Public Input No. 106-NFPA 70E-2021 [Global Input]

Action: Delete sections 90.1 through 90.5 and reinsert revised and rearranged 90.1 through 90.5 to comply with the NEC Style Manual. Also incorporate a new 90.6 Units of Measurement to align with the 2020 NEC Style Manual and Section 90.9 of the NEC.

Figure 100.0 Available Fault Current.

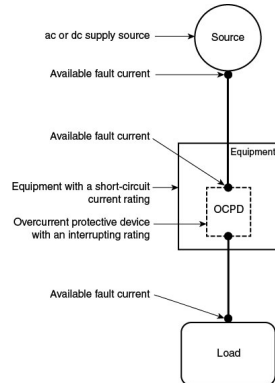
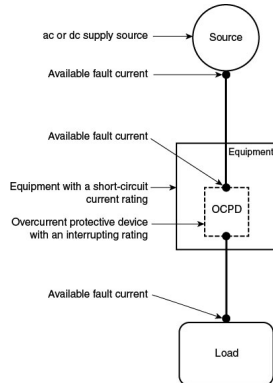
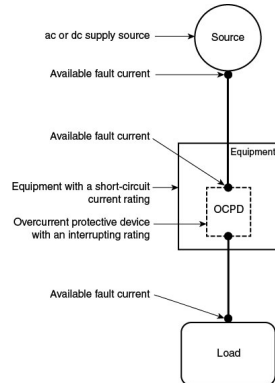
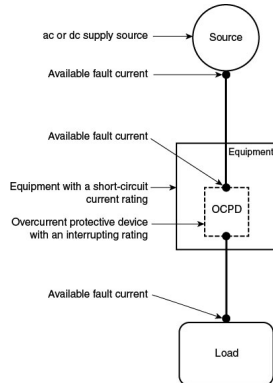
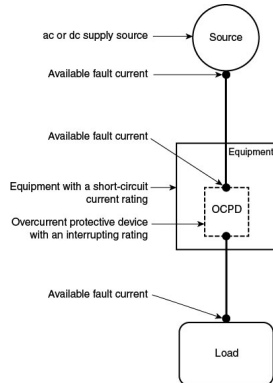
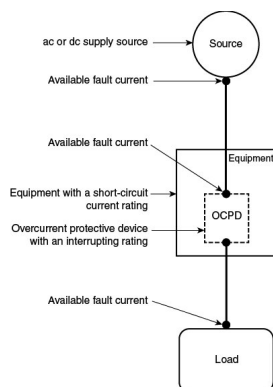
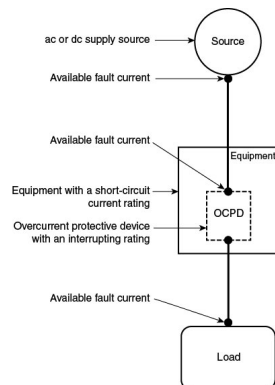
Informational Note No. 1: - See Figure 100.0. A short circuit can occur during abnormal conditions such as a fault between circuit conductors or a ground fault.- See Figure 100.0 -

Figure R.3.1(a) Capacitor Electric Shock Circuit.

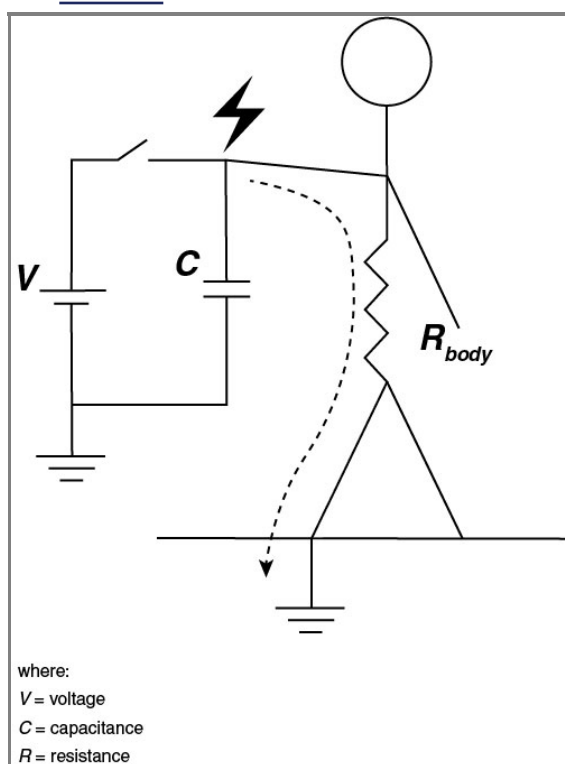
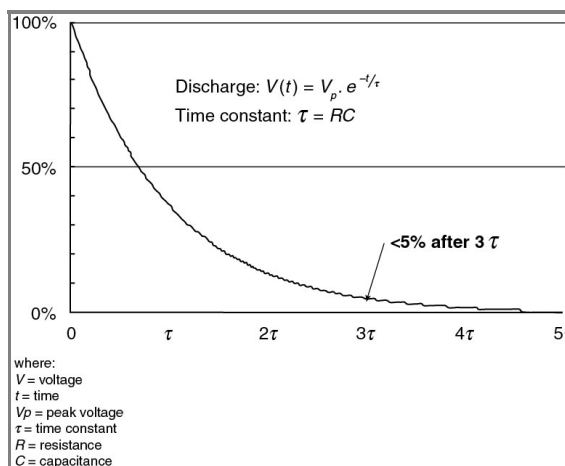
The capacitor electric shock hazard from a capacitor to a person is an impulse electric shock with an exponential decay curve. The severity of the electric shock is related to the amount of energy (joules) delivered and the time in which the energy is delivered. Injuries from electric shock caused by a capacitor shock include severe reflex action, internal and external burns, and heart fibrillation. Reflex injury can occur at energy levels as low as 0.25 joules when the capacitor voltage is over the skin breakdown threshold (about 400 volts), resulting in a very rapid delivery of the energy. Reflex action can result in injuries from falling, involuntarily coming in contact with other hazards, tearing muscles, tendons, and ligaments, or dislocation of joints. Internal burn injuries to nervous system and other tissues can occur at energies as low as 10s of joules. Heart fibrillation can happen when the voltage exceeds 100 volts and the stored energy delivered exceeds 10 joules under certain circumstances. However, even without fibrillation, a high-voltage, high-energy electric shock can cause serious injuries, either directly or through reflex action, down to as low as 0.25 joules. Instances of temporary paralysis, loss of consciousness, hearing damage, temporary loss of eyesight, burns, and dislocated joints have been reported. [See Figure R.3.1(a) for a capacitive electric shock circuit and Figure R.3.1(b) for a capacitive discharge curve.]

Ungrounded.

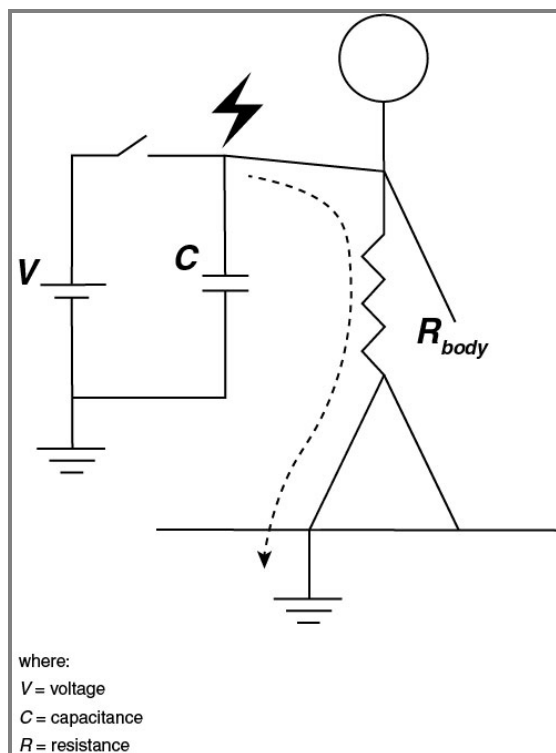
Concerning figure R31a. The circuit should be shown as a complete circuit back to the power supply. The dotted line should not go to 'ground' it should curve back around and end at the power supply. Evidently, the creator of this schematic assumed that the 'ground' symbols are connected together. The 'ground' symbol used, however, could be construed to mean 'earth' or 'soil.' This lends unnecessary confusion to the graphic. If the 'ground' systems remain, they should at least be connected together and the dotted current line should still go back to the source. There are other graphics in this appendix that have the same situation.
